Meliadine Extension

Response to Information Requests

Submitted to:
Nunavut Impact Review Board

September 26, 2022

Interested Party:	KivIA	Rec No.:	KivIA-IR-3
Re:	Data integration are lacking to understand current use of the mine site, roads and Extension area by caribou

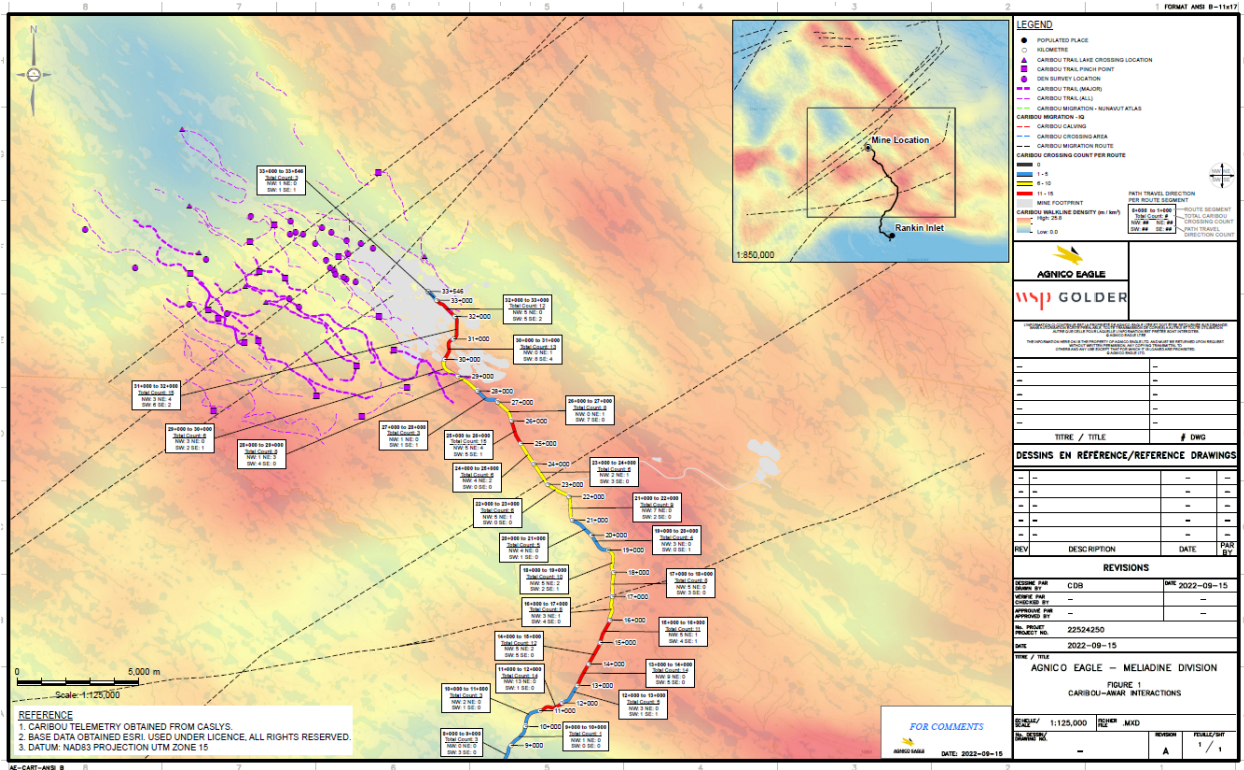
The Proponent should provide an overall assessment of current caribou movement through the mine sites, AWAR, Discovery haul road and main Extension area (wind farm, Tiriganiaq-Wolf mining area and airstrip) using Inuit Knowledge, the mapped visible trails and collar data.

It should be noted that the AWAR is not part of this Application. Additional discussions can be completed in the TAG.

The figure noted below highlights activity around the areas that are new to the Application, which is the windfarm location and the alternative airstrip. The broader discussion can be part of the TAG.

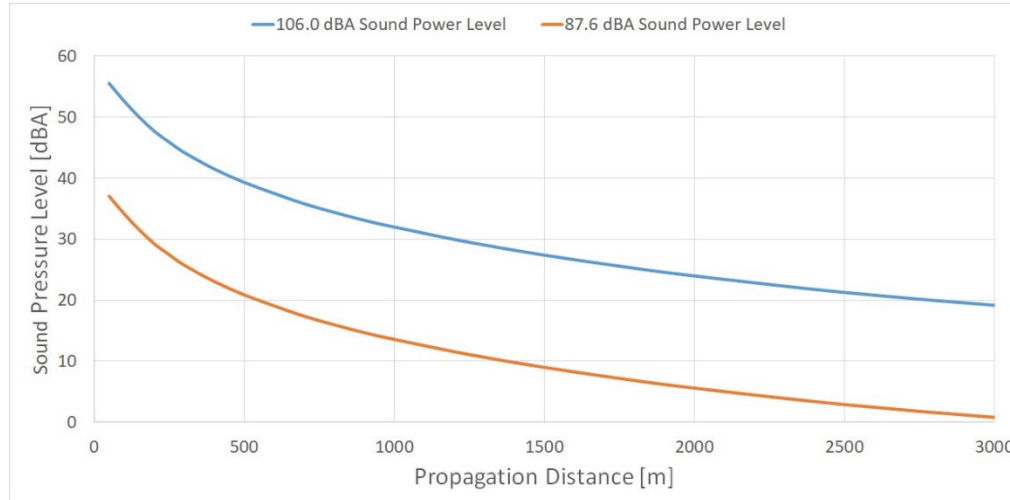
- A. Provide an explanation for how the model rapidly attenuates the wind turbine noise;
- B. Provide a graph showing measured noise level relative to distance for different wind speeds for the wind turbines and whether the noise is cumulative for more than one turbine;
- C. Explain if and how the modeled wind turbine noise includes Amplitude Modulation; and
- D. Make available Golder 2018b.

As requested, the graph below presents predicted noise level (i.e., sound pressure level) as a function of distance from a wind turbine operating with a sound power level of 106.0 dBA (i.e., maximum emissions for any wind speed) and a sound power level of 87.6 dBA (i.e., minimum emissions for any wind speed).

Interested Party:	KivIA	Rec No.:	KivIA-IR-13
Re:	Revised diagrams of Meliadine Extension features

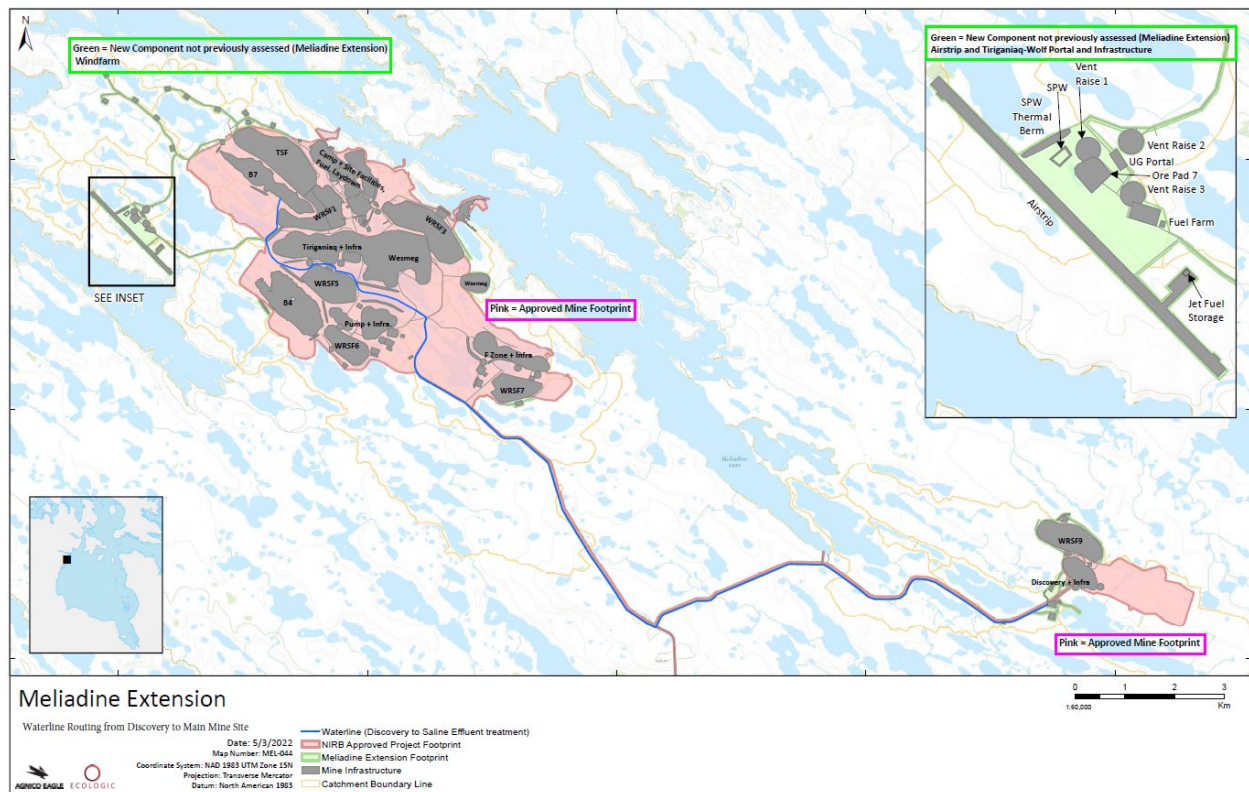
Agnico Eagle should provide updated diagrams with the location and features of the Meliadine Extension clearly identified and distinguishable from all other features noted on the above-noted figures.

Agnico Eagle refers the reader to Figure 1.1-5 (page 15 of the Meliadine Extension FEIS Addendum) which presents the approved Meliadine footprint and the new components of Meliadine Extension. It is important to note that five deposits (Tiriganiaq, F Zone, Pump, Wesmeg, and Discovery) and associated infrastructure, TSF, and WRSFs were all previously assessed and approved as part of the 2014 FEIS and are within the approved Meliadine footprint; therefore, do not need to be identified as “new” components of Meliadine Extension within the colouring scheme of this figure. The new components of Meliadine Extension were identified on Figure 1.1-5; however, to facilitate review, Agnico Eagle has provided an annotated figure to outline the features.

Interested Party:	KivIA	Rec No.:	KivIA-IR-14
Re:	Location of wind turbines that will be constructed in the first phase of the windfarm

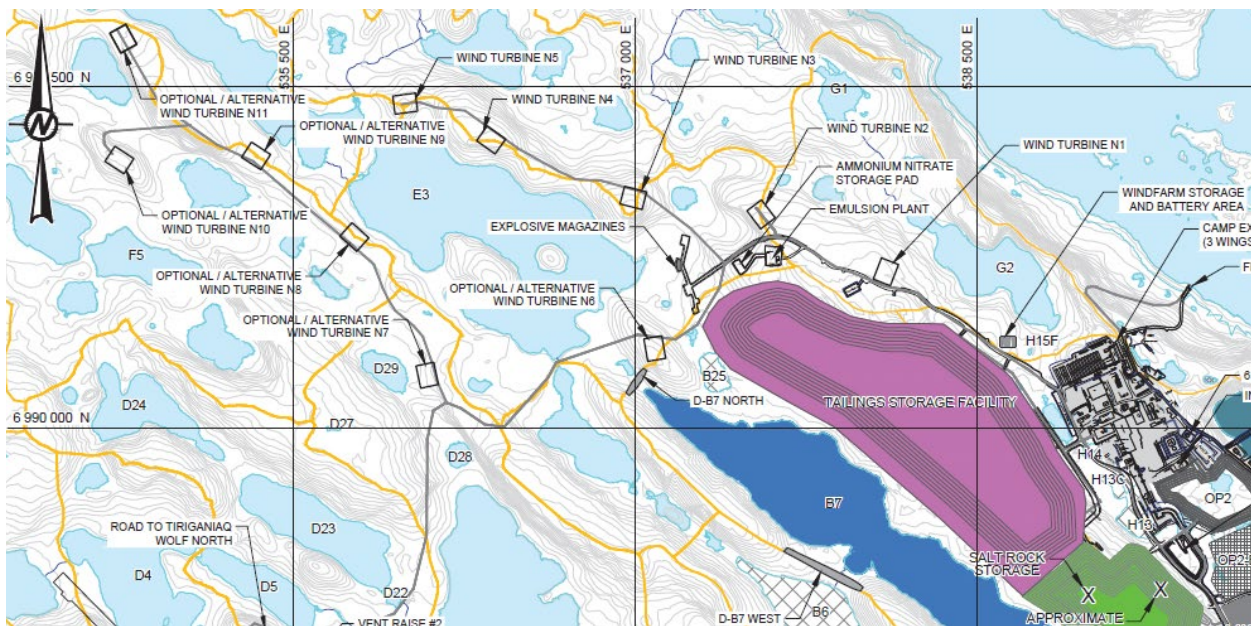
Agnico Eagle should provide an updated diagram (Figure 2.3-2) clearly showing the location of wind turbines N1 to N5.

Agnico Eagle refers KivIA to Figure 1.1-4 (page 14 of the Meliadine Extension FEIS Addendum) which identifies the locations of the wind turbines and their associated numbers. The image below provides a snapshot of Figure 1.1-4, focusing on the wind turbines and their numbering.

Figure GN-1-1: Proportion of total Qamanirjuaq collared caribou within the RSA and LSA, 1993 to 2019. Also shown is a vertical line for 2014 when Qamanirjuaq Collared Caribou would have first encountered activity associated with the AWAR (Figure 7 from Golder 2022)

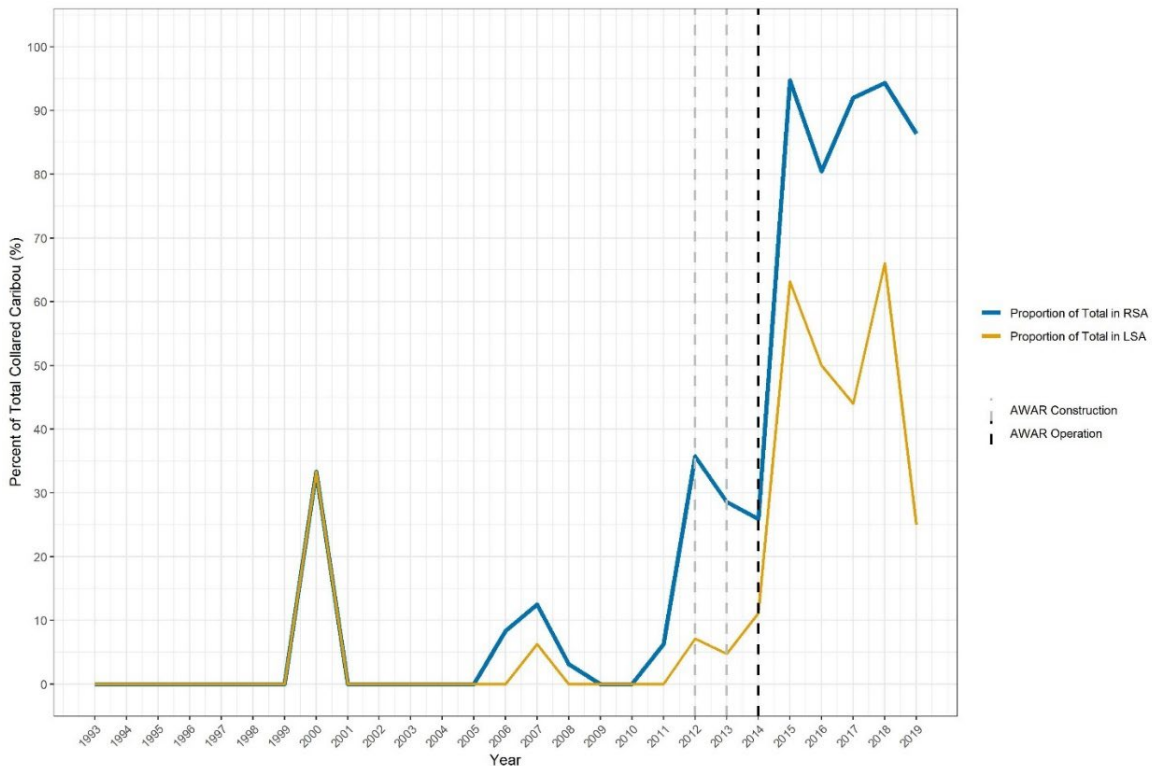
1. An analysis of trends in caribou overlap and residency time within Local Study Area (LSA) and Regional Study Area (RSA) using collared caribou collar data for the period 1993 up to the most recent year of data available. This should report information on the following metrics (in graphical and/or tabular form): (a) For each year, the percentage of collars that enter the RSA and LSA; (b) For each year, the average number of days each collar, that entered the LSA or RSA, spent in these areas.
2. A revised assessment of the potential to disrupt caribou movements using scenarios in which current trends in caribou interaction with the Project (as measured by the metrics in item 1 above) continue through the approved Project's lifespan and through the proposed Project's 11-year extension of operations.

The most recent Qamanirjuaq collared caribou data available to Agnico Eagle spanned 1993 to 2019. The metrics requested by the GN are shown in Table GN-1-1 and were previously presented as Table 9 of the 2019 Annual Terrestrial Environment Management and Monitoring Plan report (Golder 2020). The percentages of collared caribou that enter the RSA and LSA are show in Figure GN-1-1 but were previously presented as Figure 7 of Golder (2022).

Table GN-1-1 and Figure GN-1-1 show current trends of collared caribou presence in the RSA and LSA with an overall average of 5.9 days present in the RSA and 0.3 days present in the LSA since 1993. From 2014 to 2019, collared caribou averaged 13.5 days in the RSA and 1.2 days in the LSA.

As described in the 2014 FEIS (Golder 2014), Elders noted that caribou migrate through the area approximately every 6 to 12 years, which Table GN-1-1 and Figure GN-1-1 support.

Interested Party:	CIRNAC	Rec No.:	CIRNAC-IR-8
Re:	Post-Closure Arsenic Concentrations in SP B7

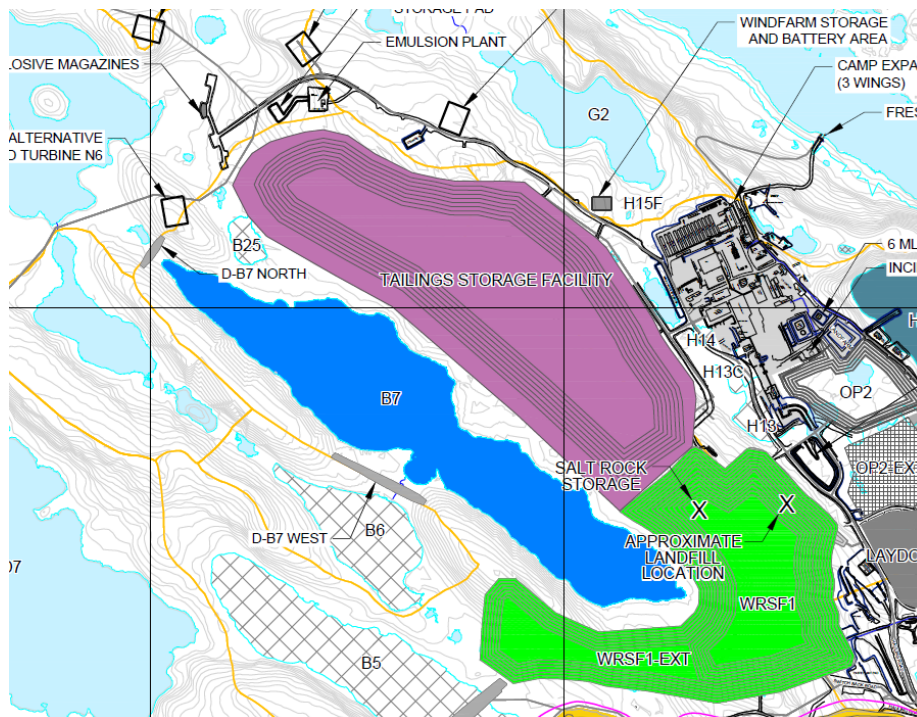
- a) Provide a figure illustrating the location of SP B7;
- b) Indicate whether aquatic species will have access to SP B7 during post-closure;
- c) Confirm that the predicted arsenic concentrations in SP B7 are spatially averaged and that localized concentrations may be higher;
- d) Indicate whether sensitivity analyses have been performed to confirm that arsenic concentrations in SP B7 during post-closure will not be substantively greater than currently predicted

The saline pond B7 (SP B7) is shown in Figure 1.1-4 of the Meliadine Extension FEIS Addendum, in the colour blue where it is labeled as B7. The image below provides a snapshot of Figure 1.1-4, focusing on the general location of SP B7.

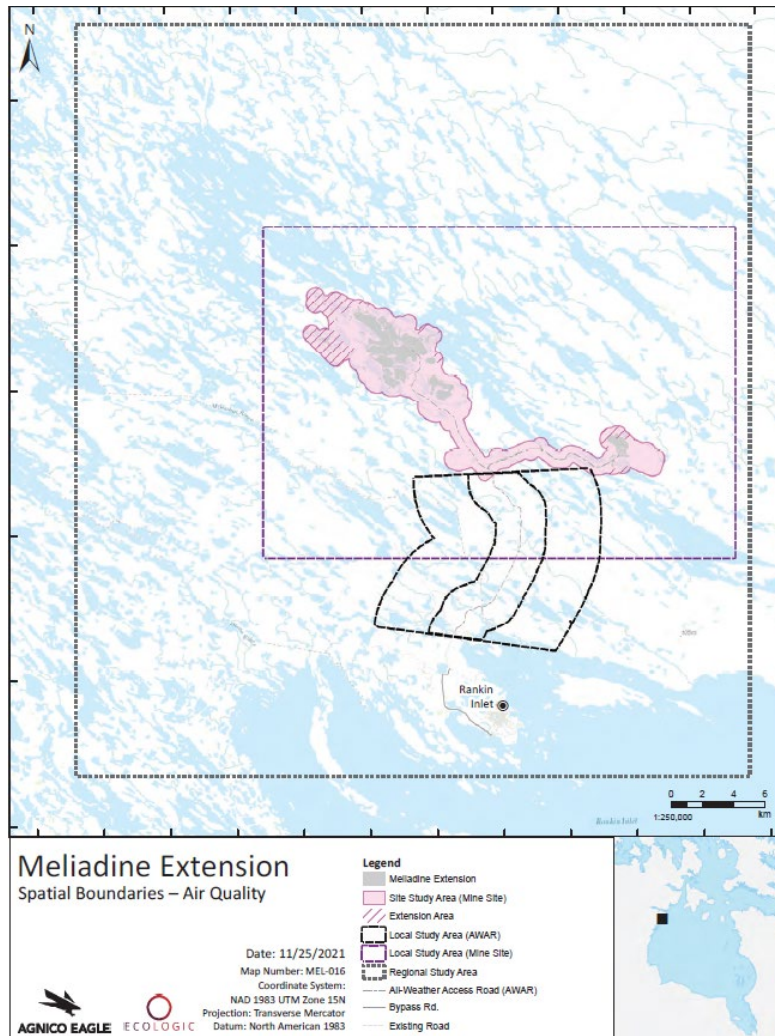
ECCC recommends that the Proponent provide additional information to resolve the ambiguity in this figure.

As outlined in the 2014 FEIS the AWAR LSA was defined as a band 3 km in width, extending 1.5 km either side of the travel surface of the roadway. As part of Meliadine Extension, outlined in Section 5.1.2.1 and Figure 5.1-1 of the Application, there was no change to the AWAR LSA. Figure 5.1-1 is provided below to facilitate the review.

Figure NRCan-8-1: Pre-mining Conceptual Groundwater Flow Directions and Distribution of Hydrostratigraphic Units

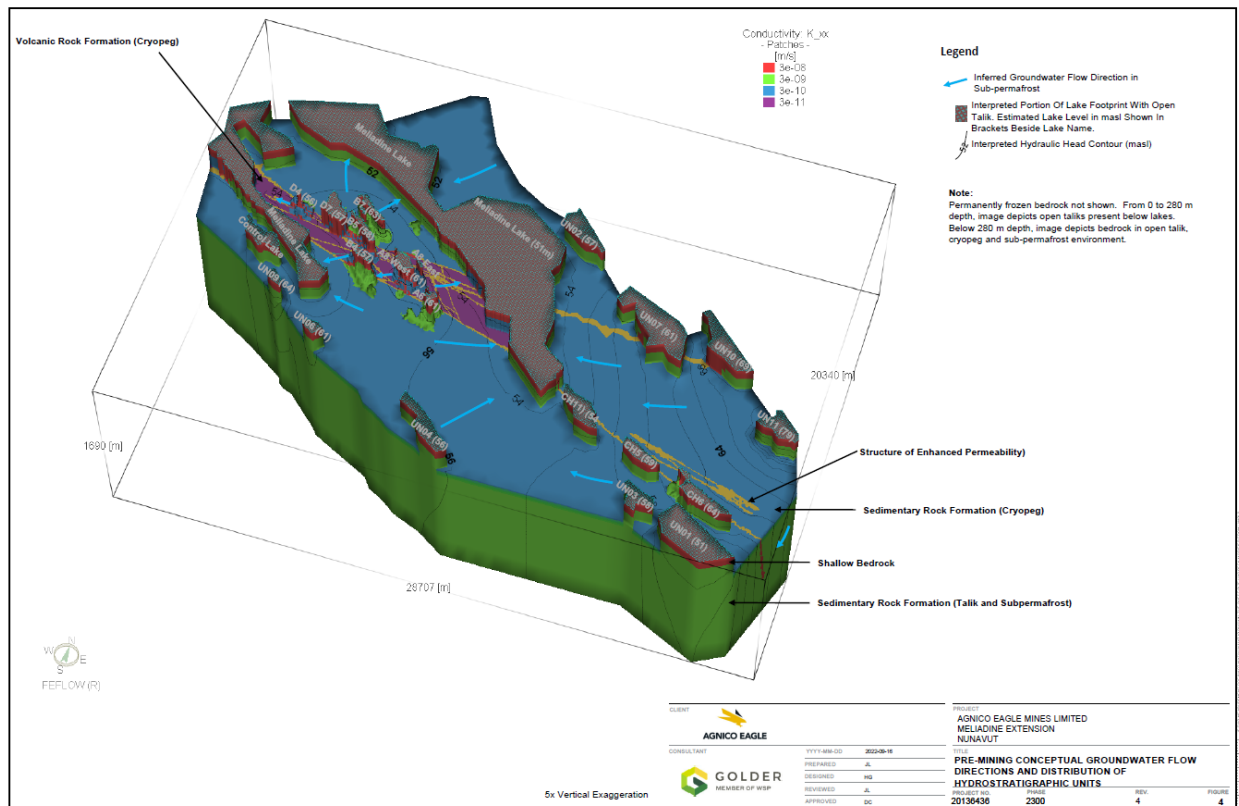
Interested Party:	NRCan	Rec No.:	NRCan-IR-8
Re:	Conceptual model flow directions–Groundwater Quantity

The corrected direction of groundwater flow is presented in Figure NRCan-8-1.
